CITY OF TONTITOWN PLANNING OFFICE

Meeting: **August 25, 2020**
Project: **Taco Bell**
Planner: Courtney McNair, Garver

WAIVER REQUEST & PRELIMINARY LARGE-SCALE DEVELOPMENT PLAN APPROVAL REQUEST

City Engineer Comments 8.17.20

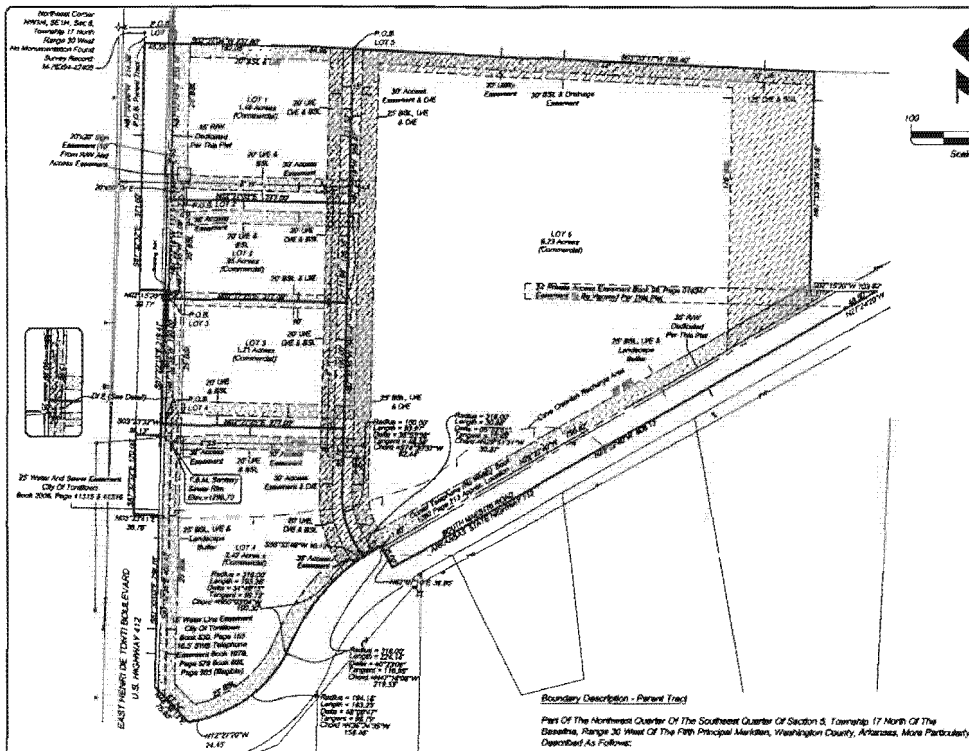
Include 25 and 50 year events in analysis.

Show downstream pipe system has the capacity for this additional flow or provide detention facilities. Note: an ARDOT permit is required and ARDOT is likely to require similar analysis
